ADDENDUM 2

ADDENDUM DESCRIPTION: 470 270000261 REQUEST FOR INFORMATION/RESPONSE

Washington Unified School District

E-Rate Cabling 2027-28: Fiber Run and Cabinet Tables for WFES and WFMS

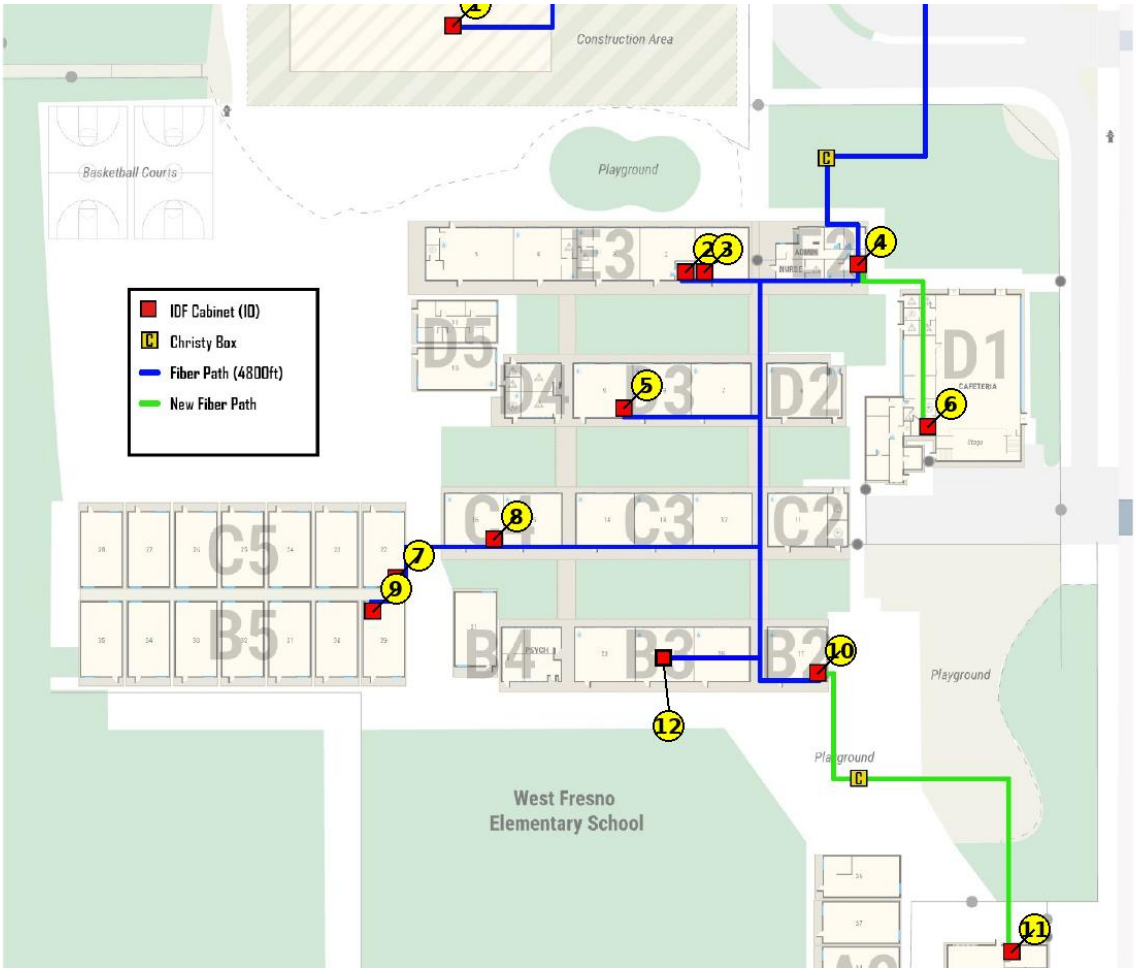
Looking at the cabinets, there is no gland plate for installation of existing panels, there are only 2-inch knockouts. This would mean all cables will need to be removed from patch panels and re-terminated, The SOW reads as though the terminations would stay static. A patch panel will not fit through a 2-inch knockout. Can you provide guidance on the expectation of cable installation into the new cabinets?

The original RFP, Section 15, pages 26–27, requires the following for cabinet replacement:

- Remove the existing MDF/IDF cabinets and install new cabinets.
- Move all in-use cabling and equipment into the new cabinets and label it.
- Coordinate cutover timing with District IT to minimize network downtime.
- Reuse existing termination blocks and patch cords where serviceable.
- Punch down existing cables that are not currently terminated in punch-down blocks.

- Response: If they have a suitable cabinet that has a hole big enough, that would work. Or cut the holes to make it large enough to get the cable though.

Drawing: WFES

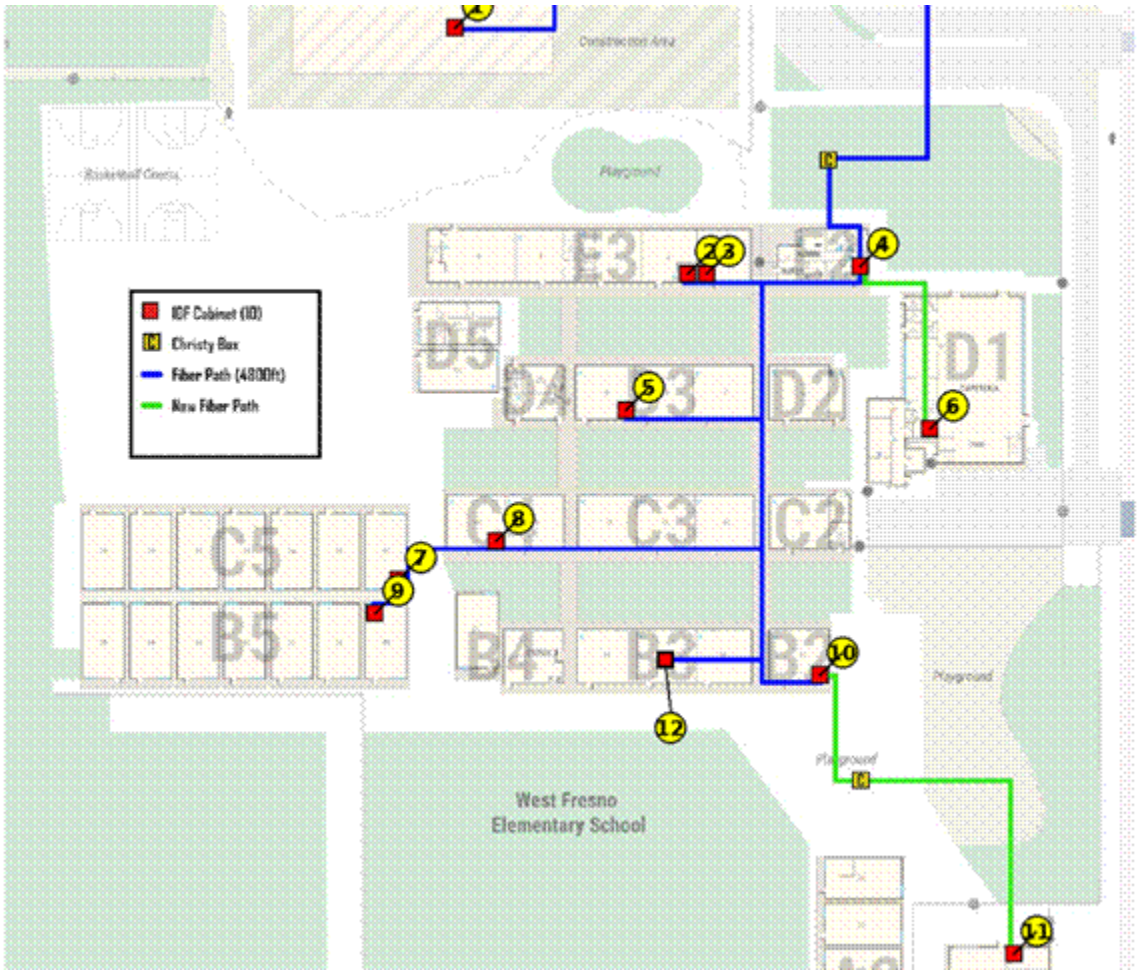
- If the tables could include Cabinet replacement or a separate table would be helpful the map counts do not match RFP and Addendum counts
  Can you provide tables for fiber runs, for WFES and WFMS, like the ones provided for the High School and AUES. Addendum changes and drawings. We were shown a cabinet in B3 at the WFES and there is no cabinet on the drawing.

B3 at WFES: You are right, there was no cabinet on the drawing. I added a cabinet at B3-15 (map number 12) and drew its fiber line to the main trunk.

- WFES map #11 (bus barn, B2 line) is excluded: no cabinet and no fiber.
- WFES B3-15: a cabinet was added at B3-15 (map #12), with a fiber line to the main trunk. The red square and blue line were added to the WFES map for this reason.

Cabinet squares are numbered to match the table. Square 12 (B3-15) and its fiber line were added.

Drawing: WFMS

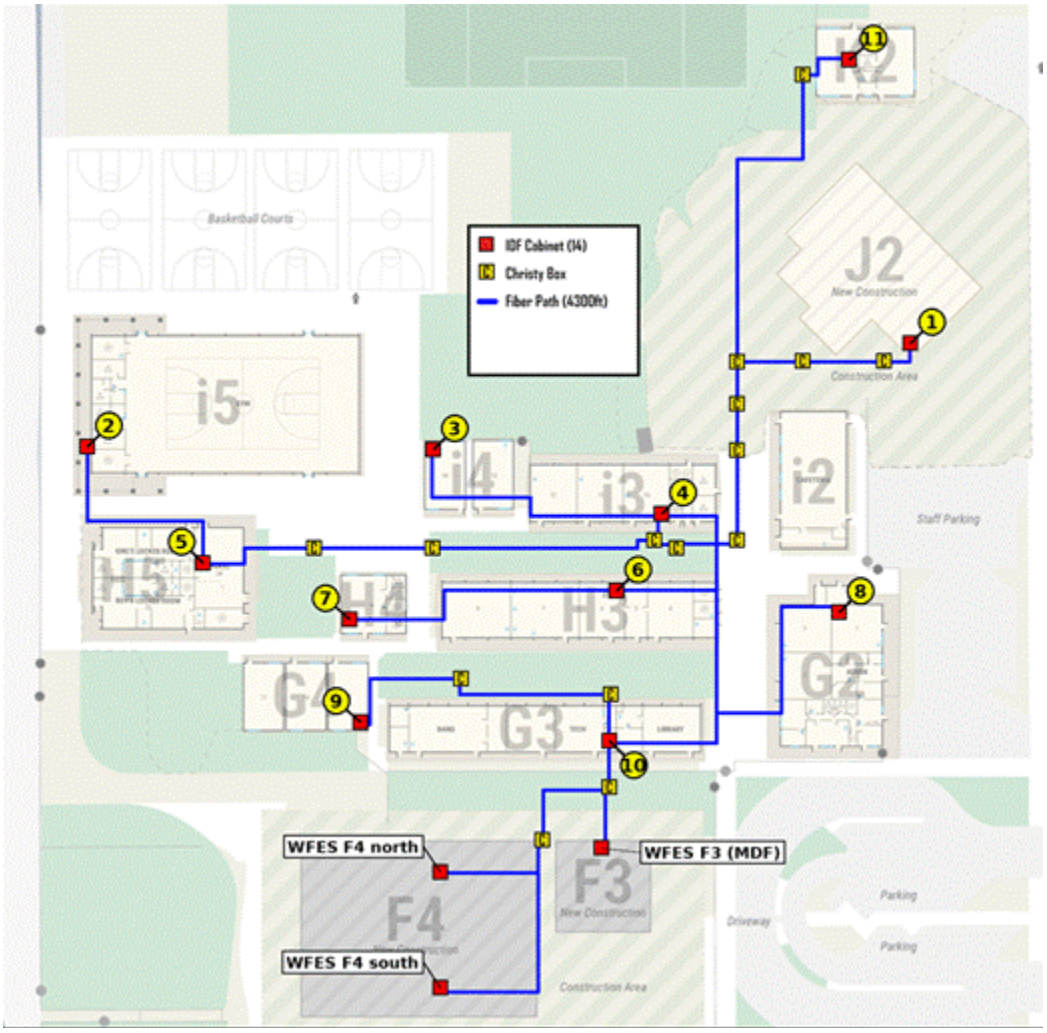
Map counts vs. the RFP and addendum counts: The legends do not match because the WFMS map also shows three WFES locations (F3 and the two F4 IDFs). The WFMS legend (14) is 11 WFMS squares plus those 3. The WFES legend (10) does not include them.

- The scope counts control over the map legends. The WFMS legend (14) counts the 11 WFMS squares plus 3 WFES squares drawn on the WFMS map (F3 and the two F4 IDFs). The WFES legend (10) does not include those three, or the B3-15 cabinet added to the map.

Cabinet squares are numbered to match the table. F3, F4 north, and F4 south are WFES locations drawn on this map.
